Access Compliance Report Public Rights-of-Way (Curb Ramps)

Main Street: PEMBROKE_DR Cross Street: BRADCLIFF_DR Location: SE

ADA ID: RPRK211013111052 Ramp Type: Type 4 - Parallel Initial Pass/Fail: Fail Overall Compliance: No Severity Score: 15

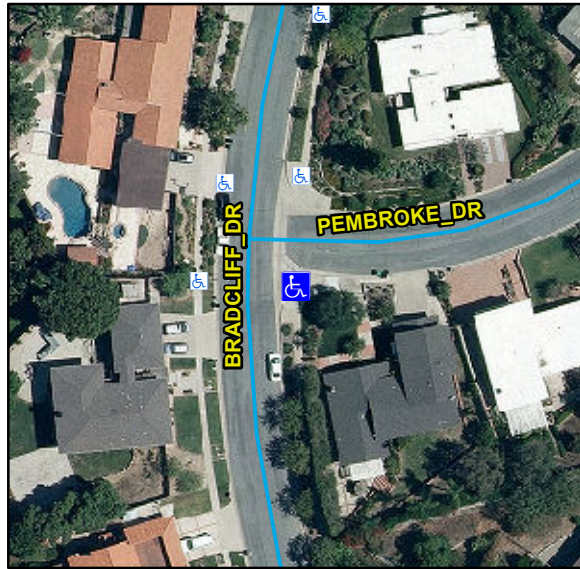
Compliance	Description	Data	Compliance	Description	Data
N/A	Ramp Length LT (in)	124	N/A	Ramp Length RT (in)	130
Yes	Ramp Width LT (in)	95	Yes	Ramp Width RT (in)	110
Yes	Ramp Run Slope LT (%)	3.5	Yes	Ramp Run Slope RT (%)	7.6
No	Ramp Cross Slope LT (%)	6	No	Ramp Cross Slope RT (%)	3.3
N/A	Landing Present	N/A	N/A	DWS Provided	N/A
N/A	Landing Length (in)	N/A	N/A	DWS Contrast	N/A
N/A	Landing Width (in)	N/A	N/A	DWS Length (in)	N/A
N/A	Landing Run Slope (%)	N/A	N/A	DWS Full Width	N/A
N/A	Landing Cross Slope (%)	N/A		DWS Offset Type	N/A
N/A	Landing Movement Obstructed?	N/A	N/A	DWS Offset Left (in)	N/A
	Landing Movement Type	N/A	N/A	DWS Offset Right (in)	N/A
N/A	Landing Shared	N/A			
N/A	Clear Space	Yes			
N/A	Clear Space To Crosswalk (in)	N/A			
N/A	Marked Crosswalk 1	No	N/A	Marked Crosswalk 2	No
	Crossing 1 Direction	N		Crossing 2 Direction	W
	Marked Crosswalk 1 Width (in)	N/A		Marked Crosswalk 2 Width (in)	N/A

N/A	Ramp Inside Crosswalk 1	N/A	N/A	Ramp Inside Crosswalk 2	N/A
	Crossing 1 Slope (%)	0.6		Crossing 2 Slope (%)	4.9
	Crossing 1 Cross Slope (%)	2.5		Crossing 2 Cross Slope (%)	2.2
N/A	Gutter Ponding	N/A	N/A	Curb Slope	7.4
No	Gutter Lip Height (in)	0.25		Road Run Slope (%)	0.4
N/A	Gutter Run Slope (%)	N/A		Road Cross Slope (%)	1.2
N/A	Gutter Cross Slope (%)	N/A	Yes	Perpendicular Joint Present	Yes
Yes	Overall Surface Condition	Acceptable			
	Cross Gutter Present?	Yes		Spandrel Present?	Yes
	Replace Cross Gutter?	No		Replace Spandrel?	No

Remove & Replace Curb Ramp With Two New Directional Ramps or Equivalent. Grind Gutter Lip.
